APPEAL SUMMARY

Appeal ID: 24862	Project Address: 4058 N Mississippi Ave
Hearing Date: 5/12/21	Appellant Name: Melynda Retallack
Case No.: B-003	Appellant Phone: 5037015277
Appeal Type: Building	Plans Examiner/Inspector: David Wood
Project Type: residential	Stories: 1 Occupancy: R Construction Type: V-B
Building/Business Name:	Fire Sprinklers: No
Appeal Involves: Addition to an existing structure, Reconsideration of appeal	LUR or Permit Application No.: 19-236164-RS
Plan Submitted Option: pdf [File 1]	Proposed use: Live-Work

MISSISSIPPI WORKSHOP

1.10

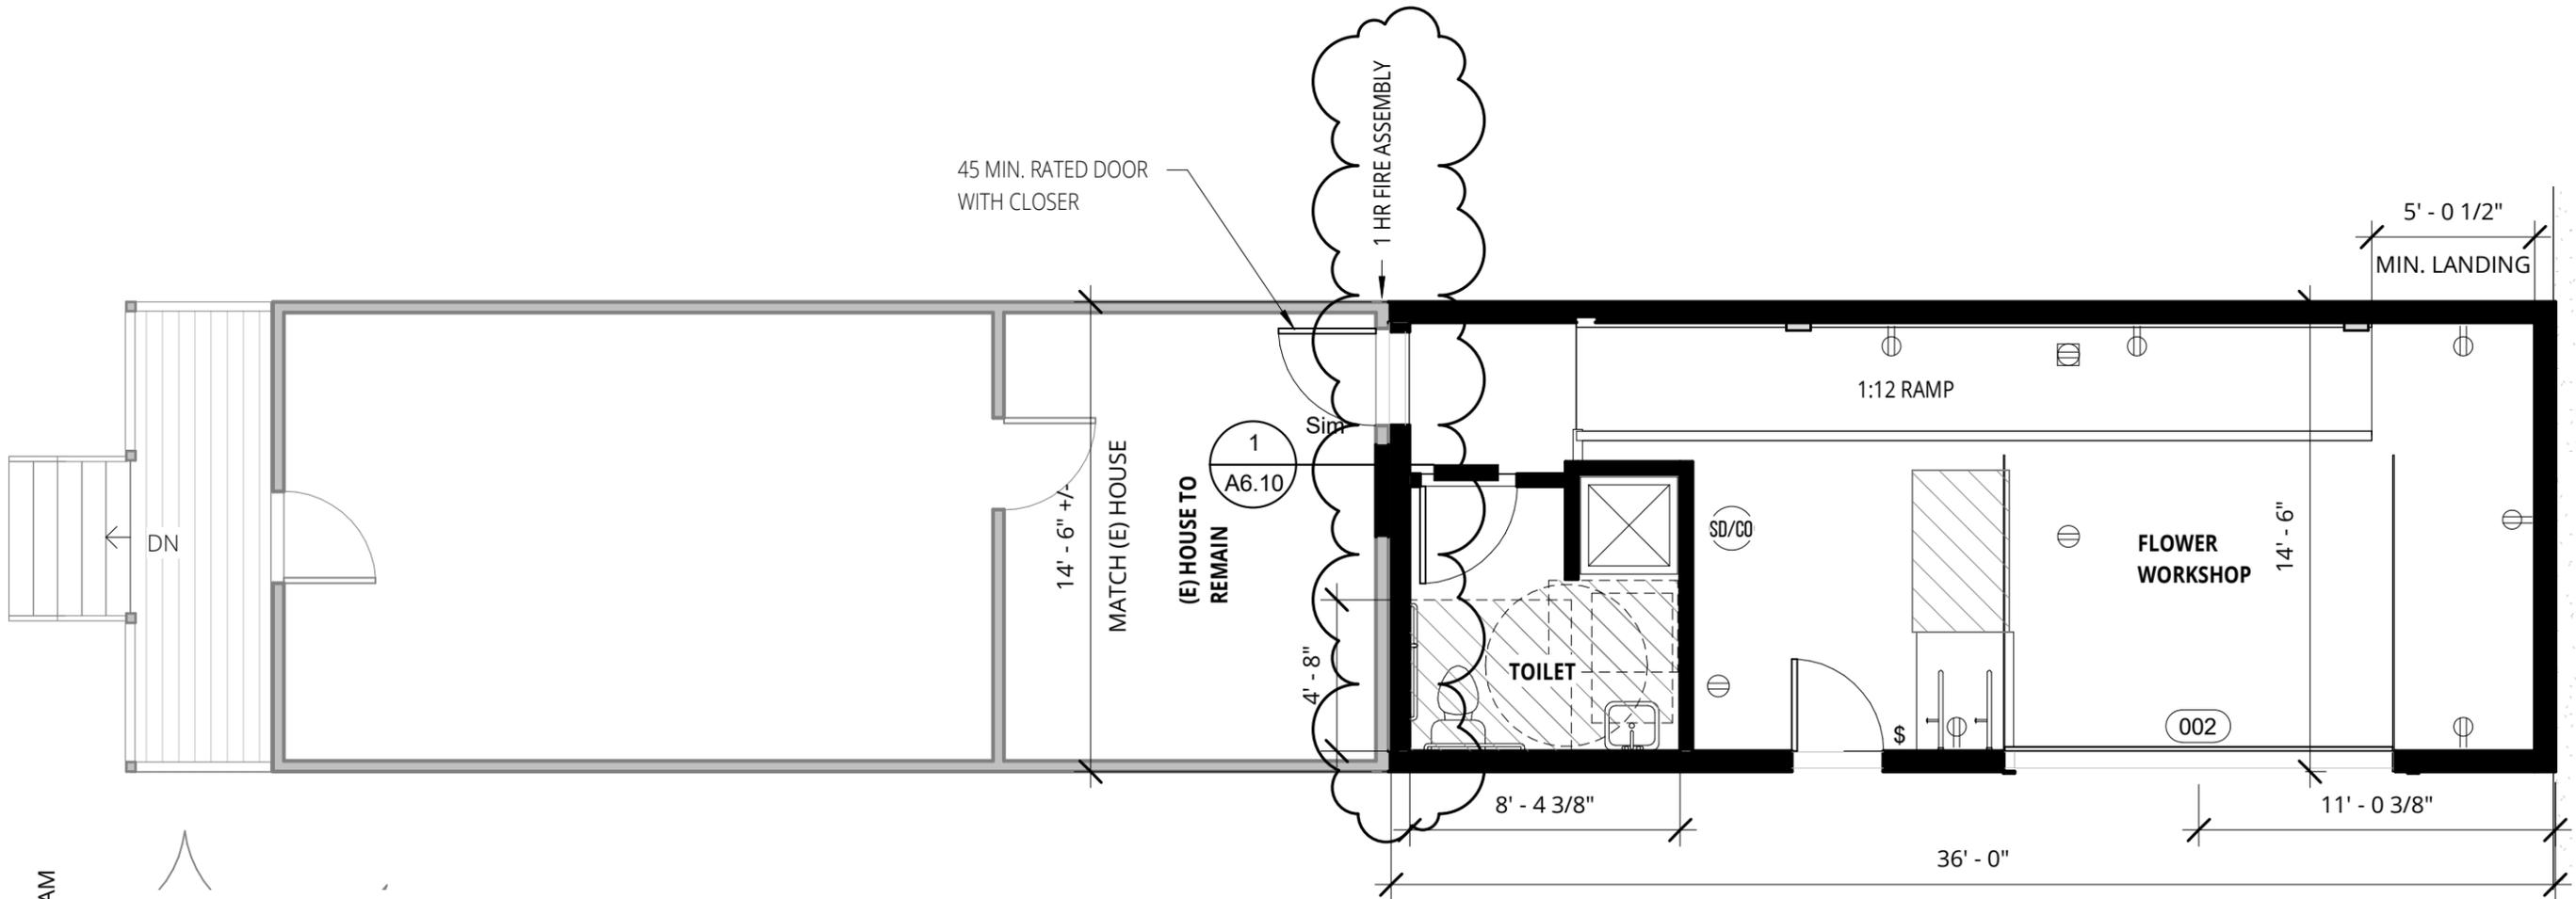
Code Section	ORSC R101.2(5), OSSC 419
Requires	Per the building plans examiner - under ORSC, live/work in townhouses must meet OSSC 419. OSSC 419 - Live/work requires NFPA 13D sprinklers throughout.
Code Modification or Alternate Requested	This building is not a townhouse per the definitions in the ORSC. This is a detached single family, 1-story home (w/ basement) with a single story flower arrangement workshop proposed to be attached at the back. We propose building a 1-Hour fire rated assembly between the residential use (fire side) and the workshop as an alternate to this requirement.
Proposed Design	<p>We propose building a 2-Hour fire partition wall between the residential use and the workshop as an alternate to this requirement. This will be a wood stud wall with (2) layers of fire rated gypsum board on both sides - per UL U301. See attached sketch.</p> <p>Reconsideration text:</p> <p>We propose building a 1-Hour fire rated assembly between the residential use (fire side) and the flower arrangement workshop as an alternate to this requirement. This will be a wood stud wall with (2) layers of fire rated gypsum board on the fire side (existing house) running from the concrete basement wall to the bottom of the roof sheathing. The underside of the ceiling/truss assembly within 4' of this wall on both sides will also have (2) layers of 5/8" gyp bd. No openings are allowed in the roof within 5' of the fire wall on either side, the roofing to be Class B roof covering, and the door will be 20 min. fire rated with a closer. Assembly to meet U356 BXUV FIRE RESISTANCE RATING ANSI/UL 263 - 1 HOUR. A parapet is not required per 705.11 exp 4. See attached sketches – 1.00, 1.10, A5.00 AND A6.10.</p> <p>2nd Reconsideration text:</p> <p>We propose building a 1-Hour fire rated assembly between the residential use (fire side) and the flower arrangement workshop as an alternate to this requirement. This will be a wood stud wall with (2) layers of fire rated gypsum board on the fire side (existing house) running from the</p>

concrete basement wall to the bottom of the roof sheathing. The underside of the ceiling/truss assembly within 4' of this wall on both sides will also have (2) layers of 5/8" gyp bd. and the gyp. bd. Will wrap to the bottom of roof sheathing. No openings are allowed in the roof within 5' of the fire wall on either side, the roofing to be Class B roof covering, and the door will be 45 min. fire rated with a closer. Assembly to meet U356 BXUV FIRE RESISTANCE RATING ANSI/UL 263 - 1 HOUR. A parapet is not required per 705.11 exp 4. See attached sketches – 1.00, 1.10, A5.00 AND A6.10.

Single family residence with attached workshop and one hour separation: Granted as proposed.

A6.10

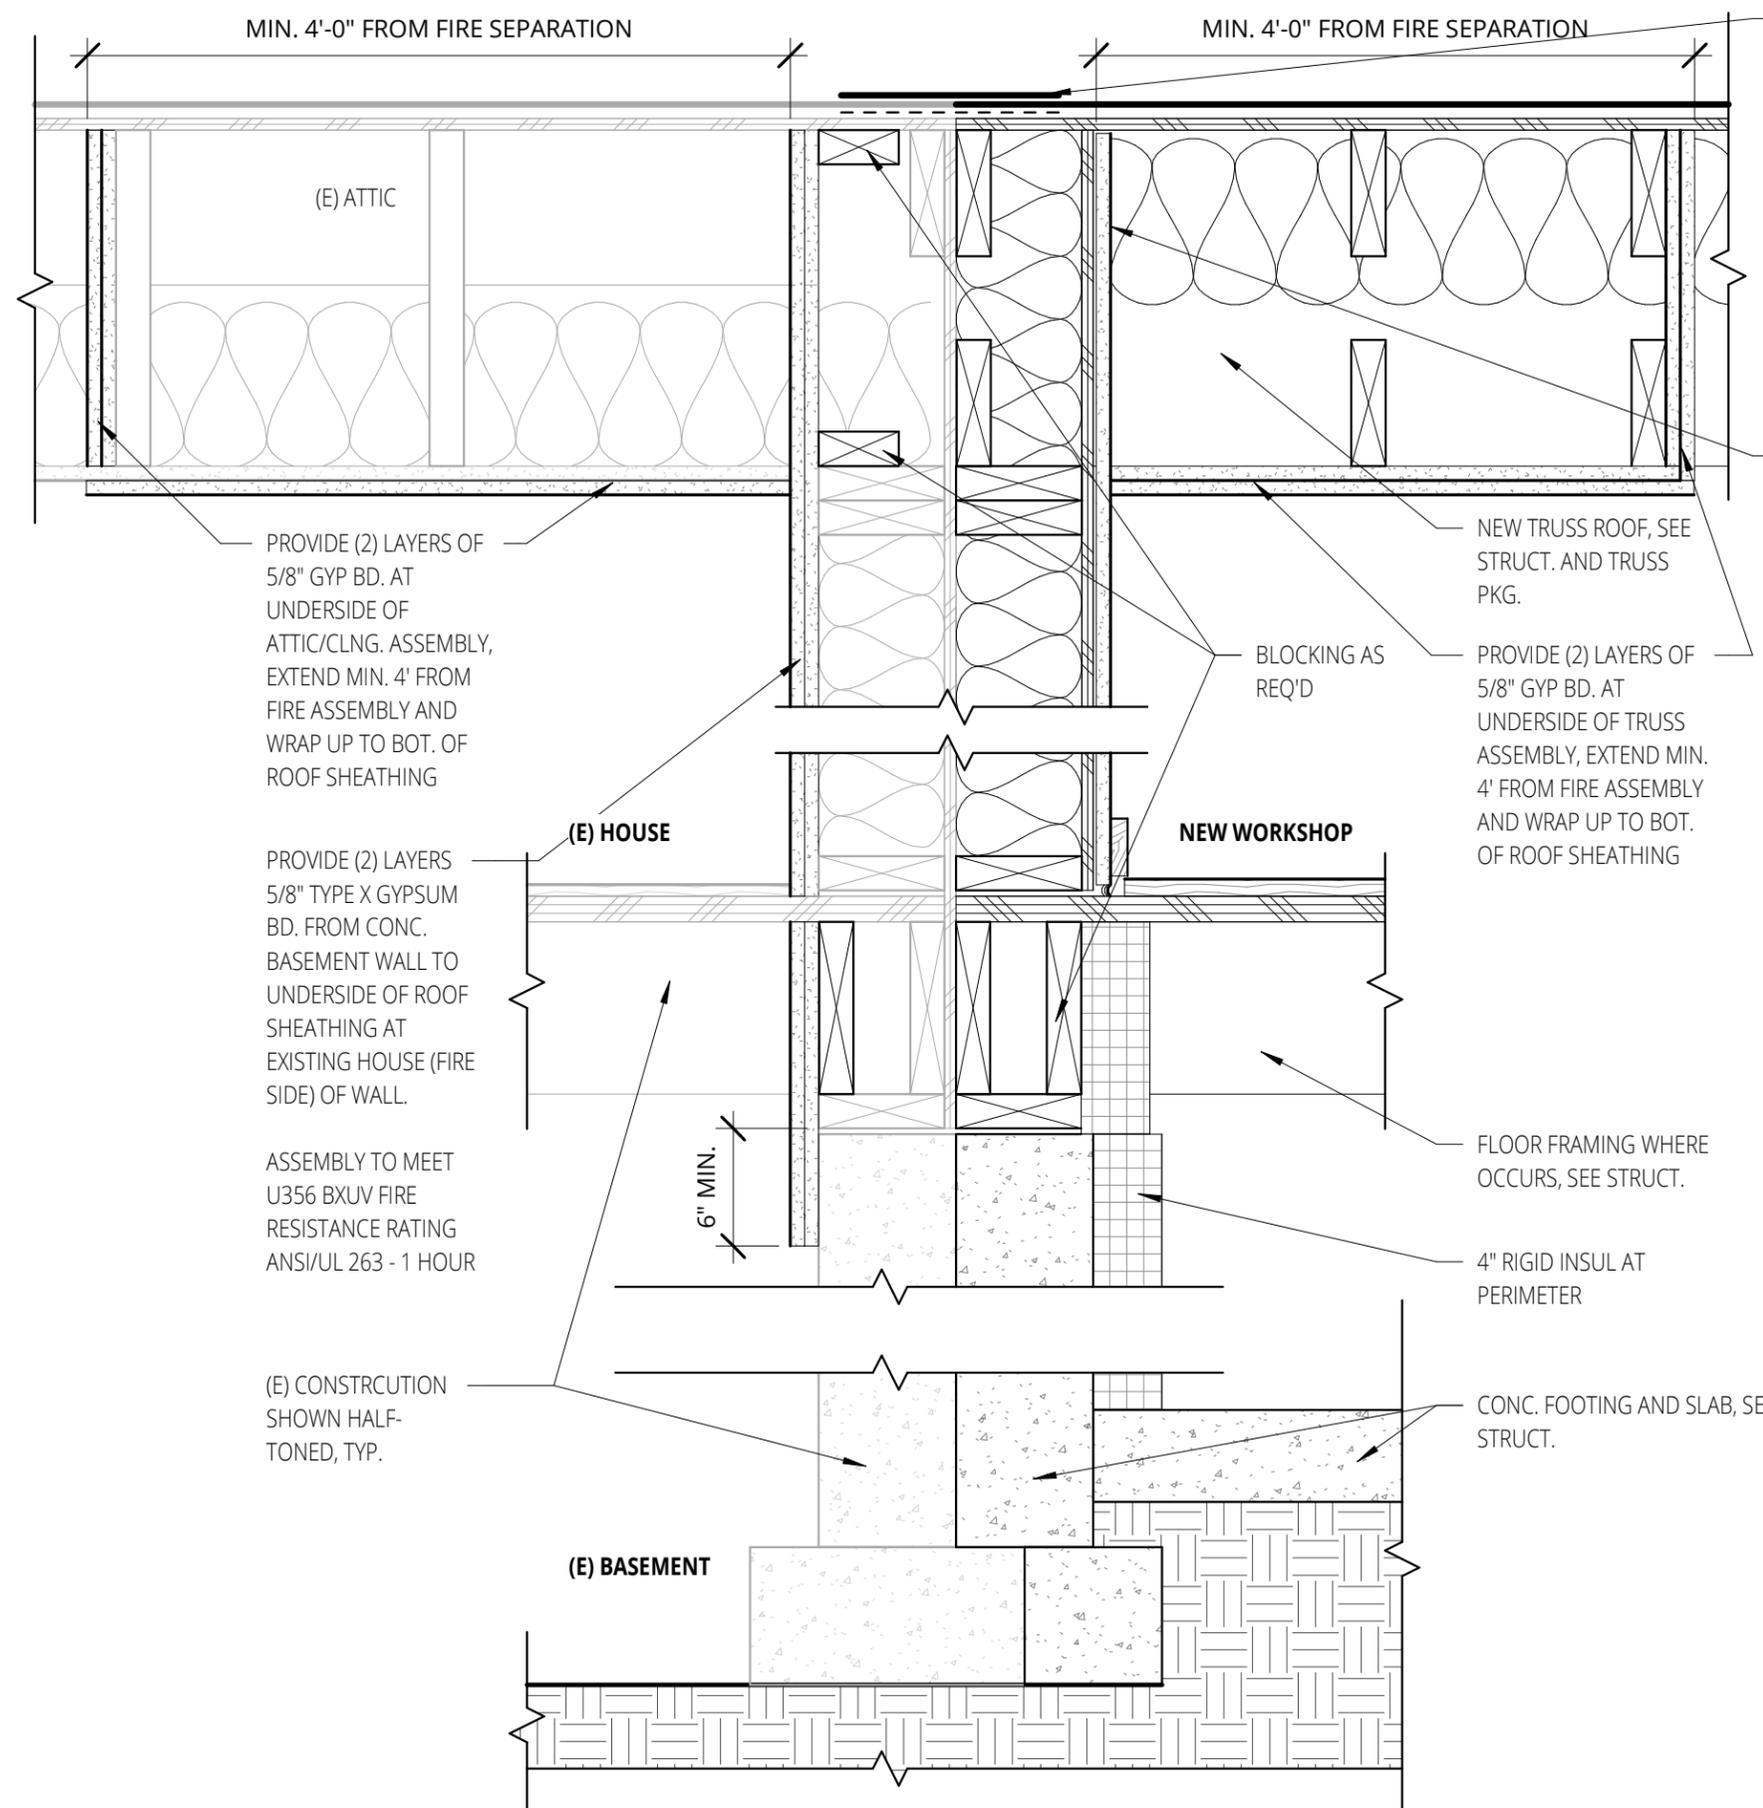
The 1-Hour assembly and 45 min. door would contain a fire from the existing house side long enough to allow occupants sufficient time to exit the single story building if a fire were to occur.
